**DEPARTMENT OF TRANSPORTATION
STATE OF GEORGIA**

SUBJECT APPROVED CONCEPT REPORT

**DEPARTMENT OF TRANSPORTATION
STATE OF GEORGIA
PROJECT CSSFT-0009-00(846)
CONCEPT REPORT**

SR 33 / US 319 at SR 33 South

Figure 1: 2036 AM & PM Peak Hour Traffic Volumes

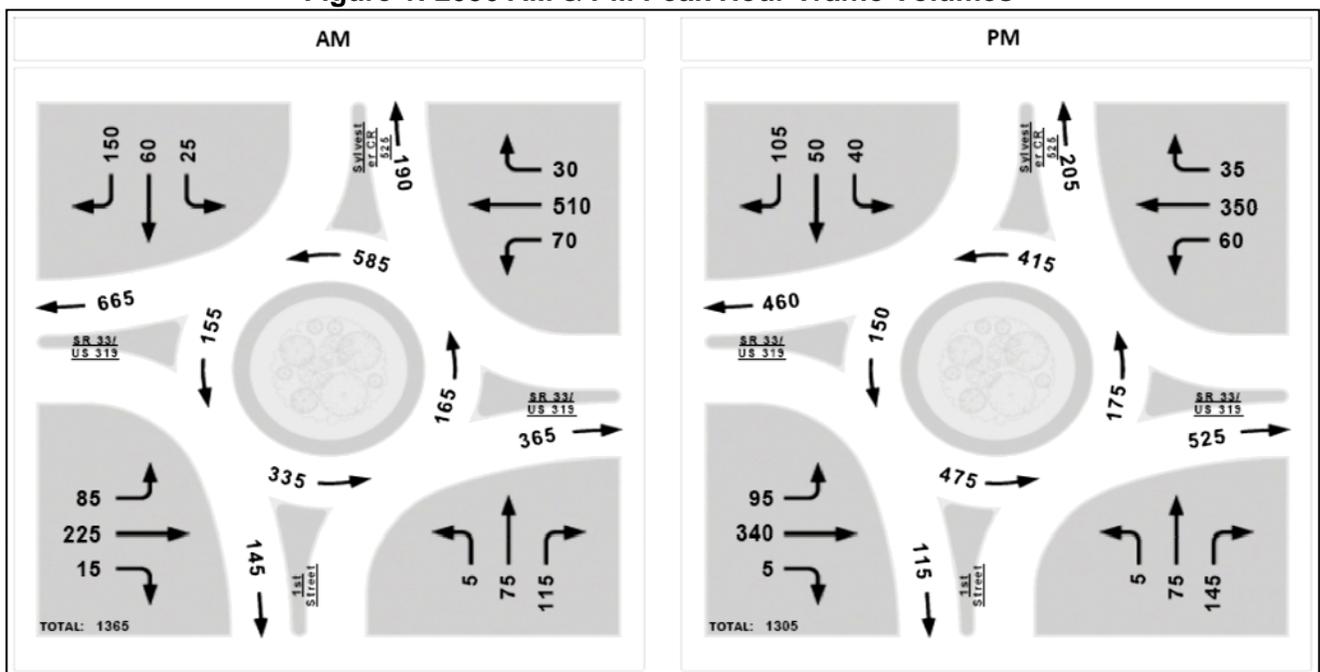
The operational analysis was performed with the 2036 traffic forecasts for a single lane roundabout with bypass lanes on the northbound and southbound SR 33/US 319 legs as shown in Figure 1. The overall intersection levels of service and anticipated delay detailed by approach are listed in Table 1.

The issue is balancing safety with operational performance; a two-lane roundabout will provide more than adequate operational performance but typically will have decreased safety performance. A single lane roundabout allows for greater ability to control vehicle speed, less complexity for drivers, and shorter crossing distances for pedestrians.

We suggest proceeding with the single lane configuration based on the expected improvement in safety performance. Should there be a desire to provide excess capacity or future capacity, a two lane conversion plan could be developed to convert the roundabout entries from one lane to two in the future.

- 1. Two lane circular roadway versus a single lane roadway:** *“We suggest proceeding with the single lane configuration based on the expected improvement in safety performance. Should there be a desire to provide excess capacity or future capacity, a two lane conversion plan could be developed to convert the roundabout entries from one lane to two in the future.”*
GS&P agrees that the concept should show a single circular lane based upon design year levels of service (LOS), the simplicity of a single lane roundabout to drivers, a lesser right of way impact, and shorter pedestrian crossings.

DATE 5/25/2012	PROJECT No. 11-977
SCALE 1" = 60	FIGURE No. 2

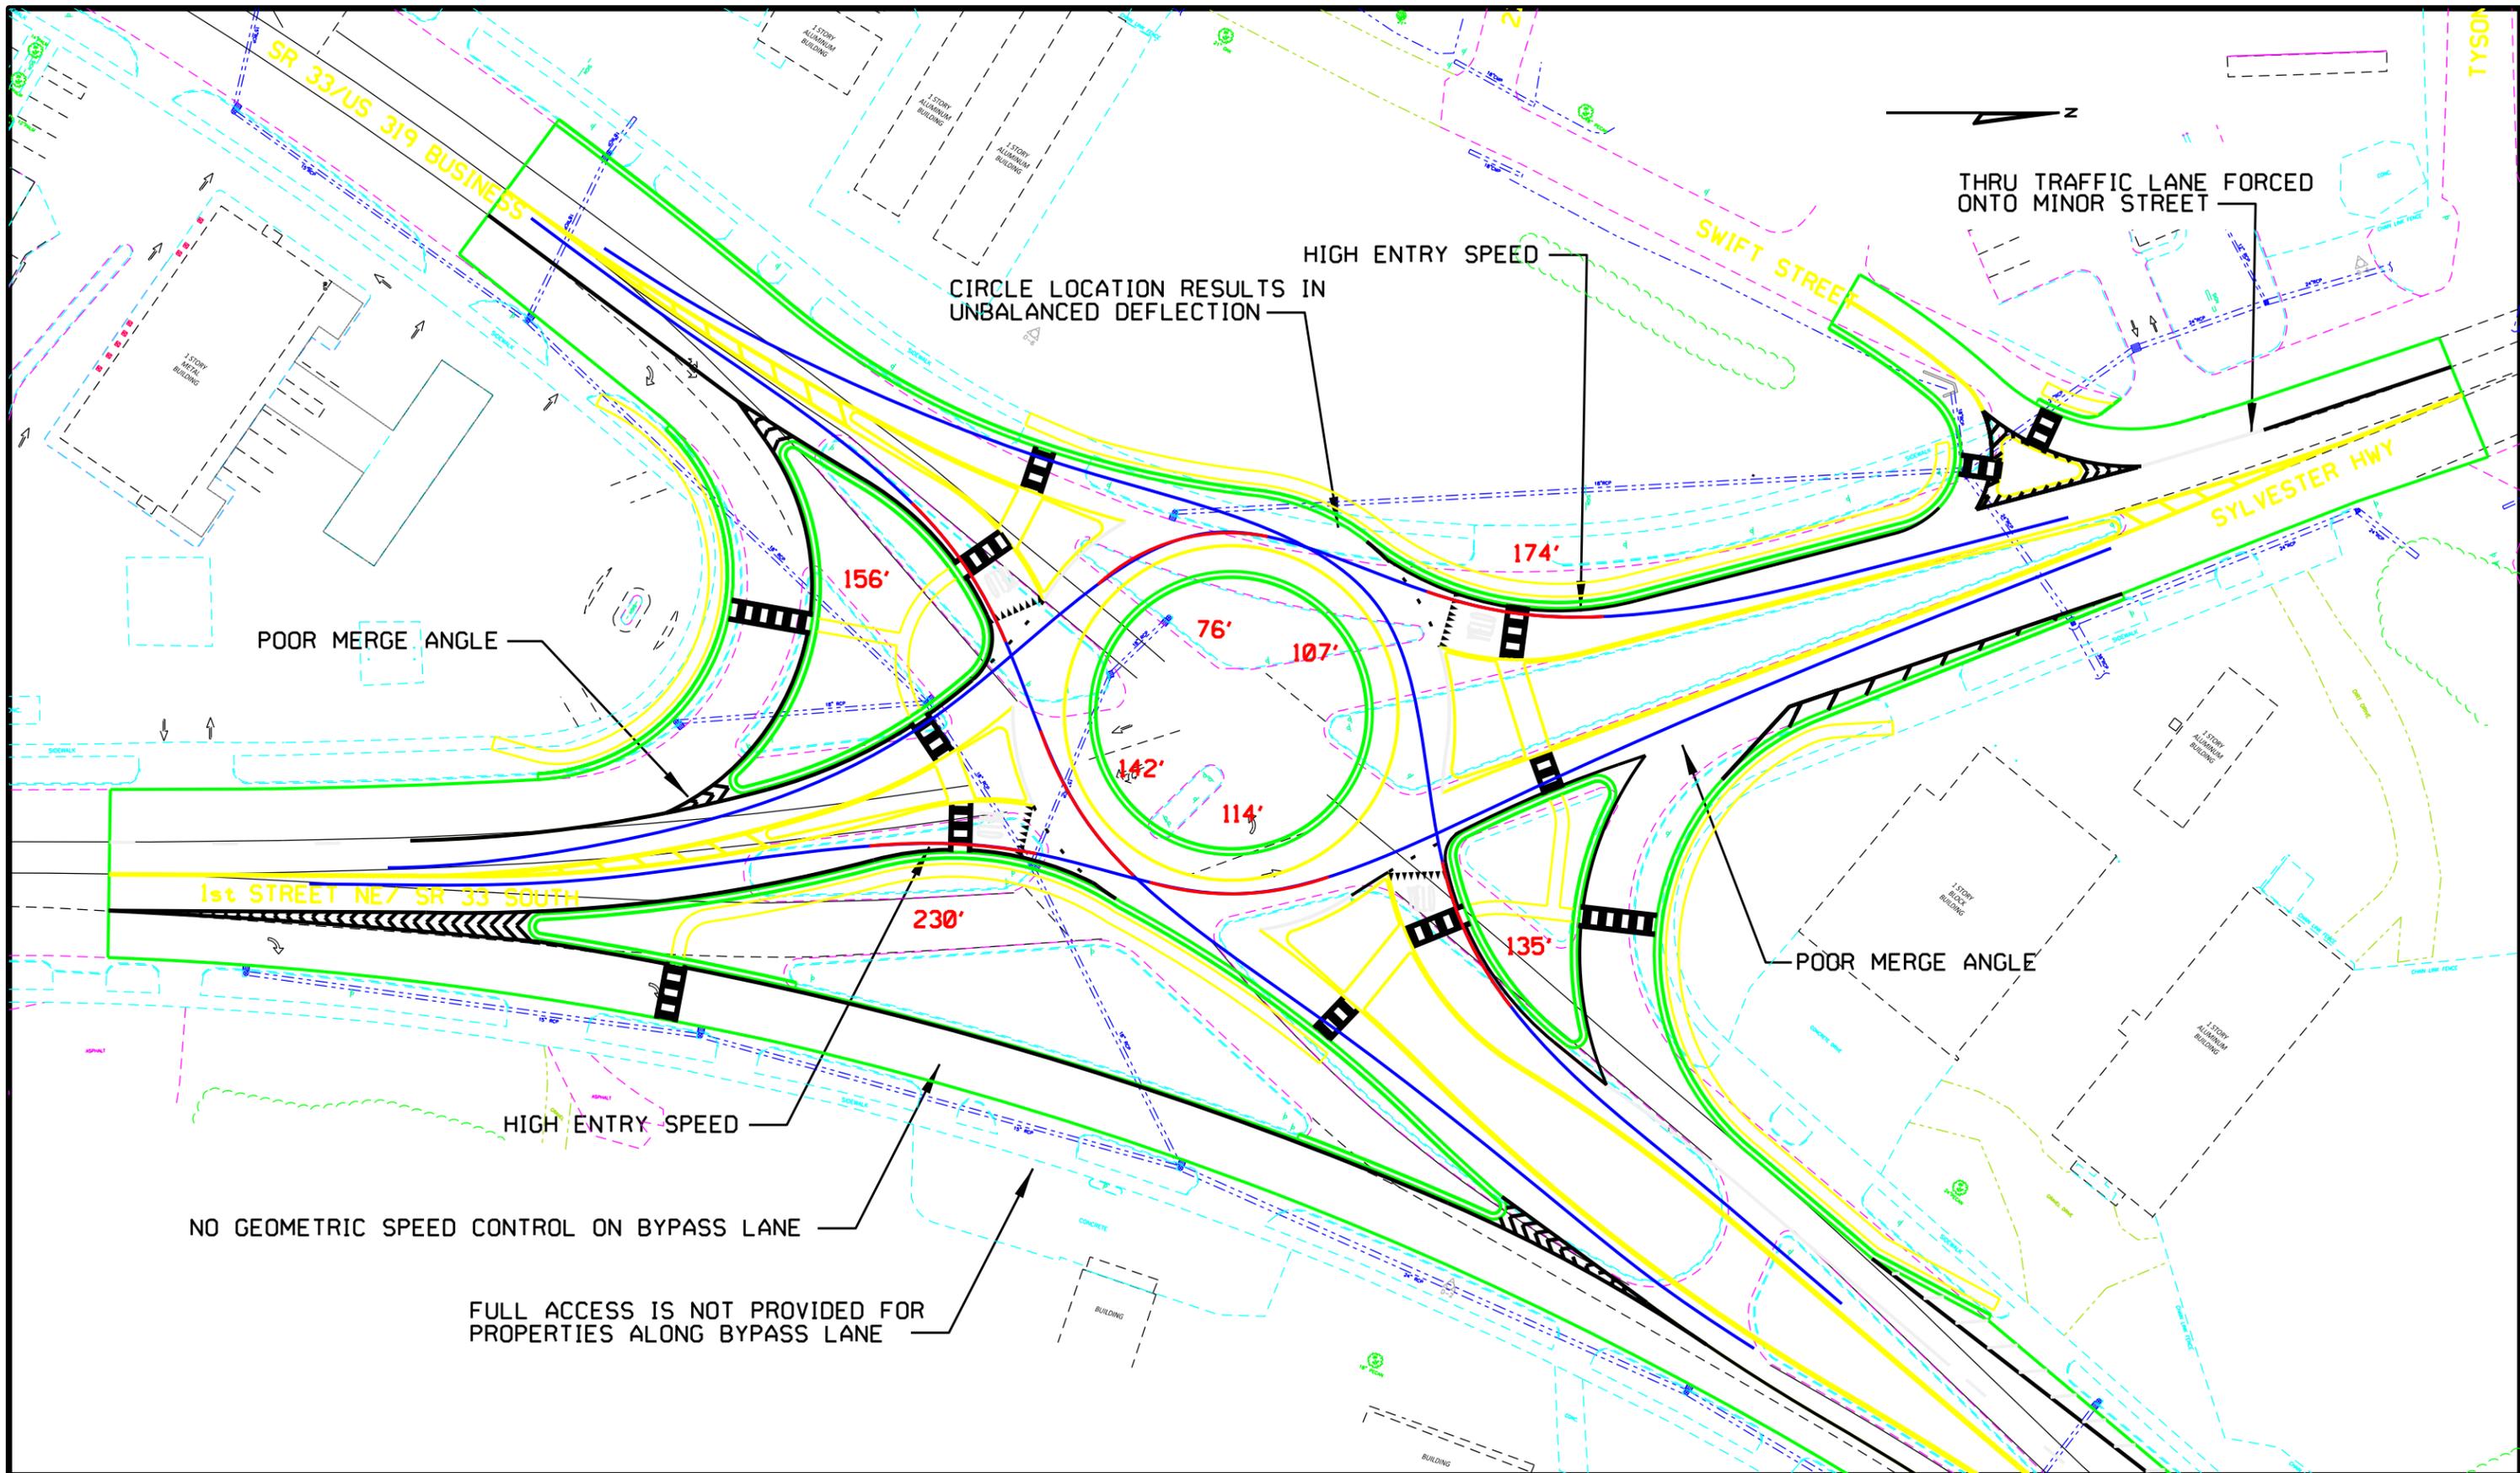
ORE has reviewed the horizontal roundabout design provided by Gresham, Smith and Partners, see Figure 2, and have provided initial comments for your consideration.

The selected inscribed circle diameter (ICD) of 173 feet is on the high side of the typical range for a single lane semi-urban roundabout. The skewed geometry of this intersection does require a distinctive ICD to provide good entry geometry for each approach. An elliptical shaped ICD would provide the ability to improve the balance of the geometry of each of the skewed entries. We sketched a version of the ellipse layout as shown on Figure 3.

The arrangement of the approach alignments and bypass lanes presents difficulty for access to some of the surrounding properties. The existing and proposed geometry requires drivers accessing the properties along the bypass lane between 1st Street and SR33/US 319 to navigate a complicated set of maneuvers to get to three legs of the intersection. Drivers must enter the stream of traffic on the bypass lane, change to the left lane very quickly after the merge with SR 33/US 319 traffic and then make a U-turn before proceeding back to the intersection. We suggest removing the free-flow bypass lane and considering a frontage road arrangement with a connection to both 1st Street and SR 33/US 319 providing full access to these properties in a low speed environment.

- 2. Inscribed Circle Size:** *“The selected inscribed circle diameter (ICD) of 173 feet is on the high side of the typical range for a single lane semi-urban roundabout. The skewed geometry of this intersection does require a distinctive ICD to provide good entry geometry for each approach. An elliptical shaped ICD would provide the ability to improve the balance of the geometry of each of the skewed entries.”*
GS&P agrees with this recommendation and has revised the concept accordingly.

- 6. Property Access:** *“The arrangement of the approach alignments and bypass lanes presents difficulty for access to some of the surrounding properties. The existing and proposed geometry requires drivers accessing the properties along the bypass lane between 1st Street and SR33/US 319 to navigate a complicated set of maneuvers to get to three legs of the intersection. Drivers must enter the stream of traffic on the bypass lane, change to the left lane very quickly after the merge with SR 33/US 319 traffic and then make a U-turn before proceeding back to the intersection. We suggest removing the free-flow bypass lane and considering a frontage road arrangement with a connection to both 1st Street and SR 33/US 319 providing full access to these properties in a low speed environment.”*

GS&P agrees with this recommendation and has revised the concept accordingly.

DATE 6/7/2012	PROJECT No. 11-977
SCALE 1" = 60'	FIGURE No. 3

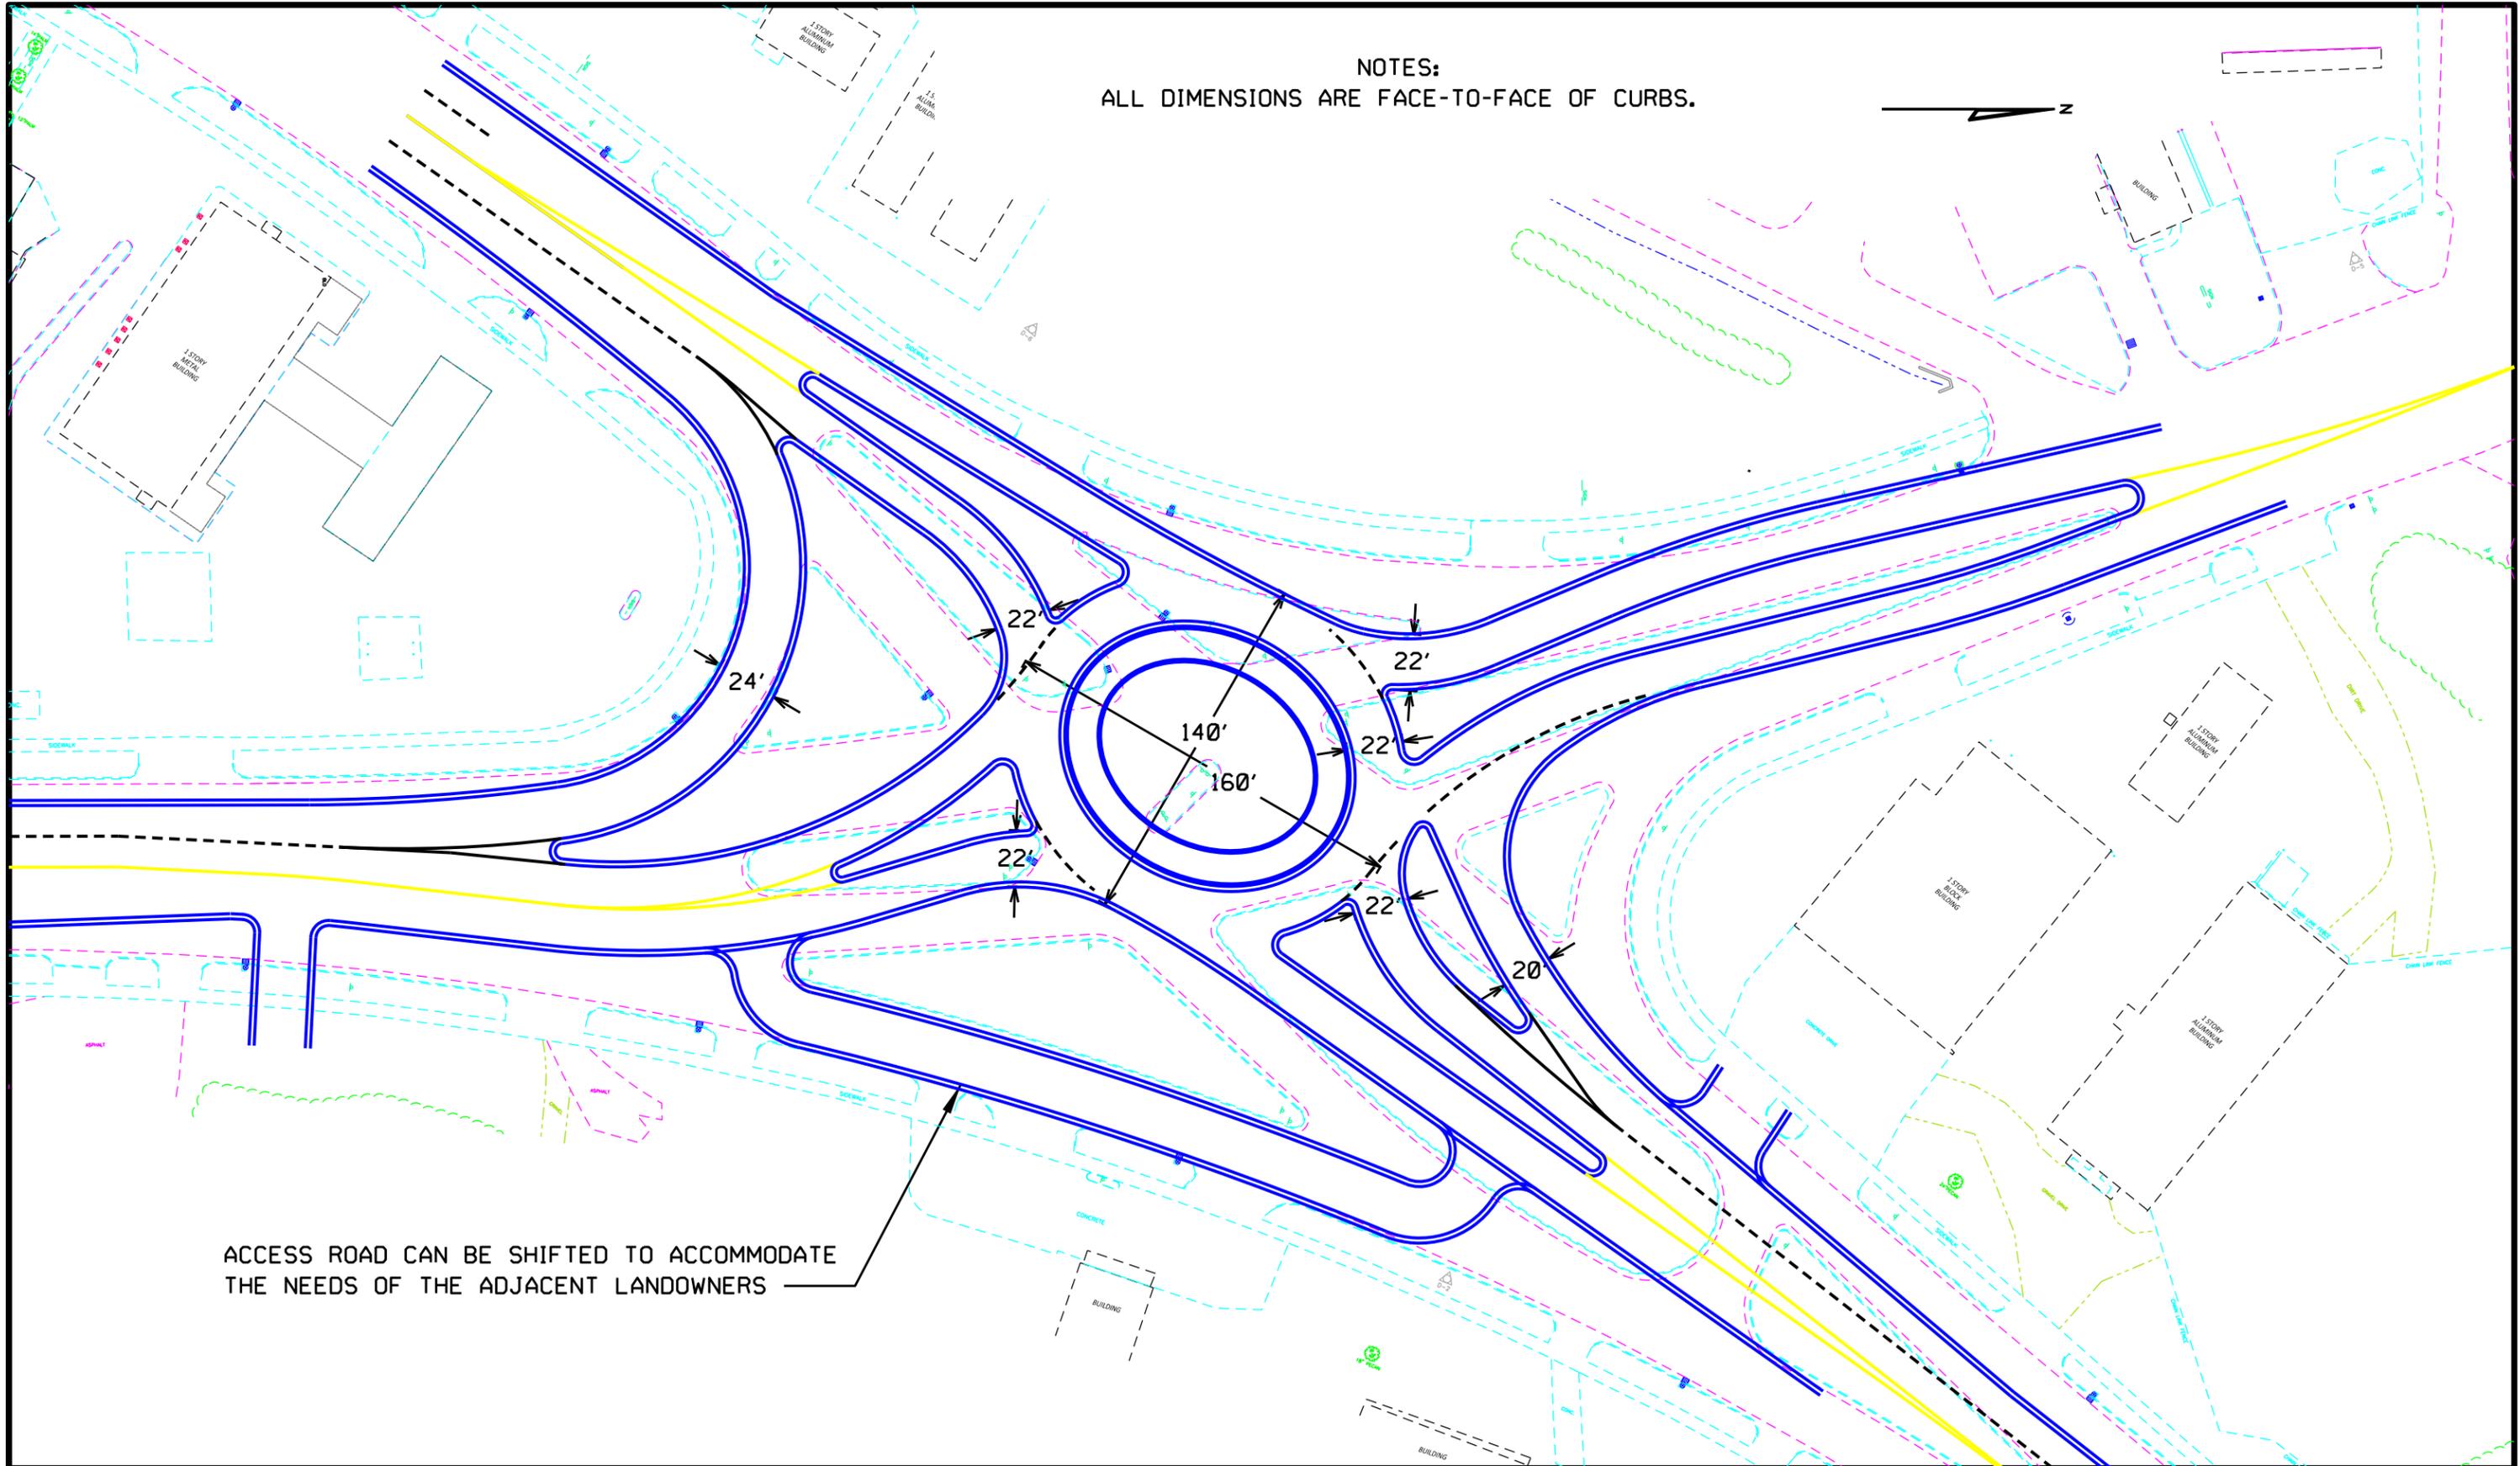
Significant overall improvements can be expected with the revision of the current proposed design. We have determined these changes necessary through an exploration of circle location and alignment of legs. We have prepared a conceptual design that addresses the issues noted above, as shown in Figure 3.

ACCESS ROAD CAN BE SHIFTED TO ACCOMMODATE THE NEEDS OF THE ADJACENT LANDOWNERS
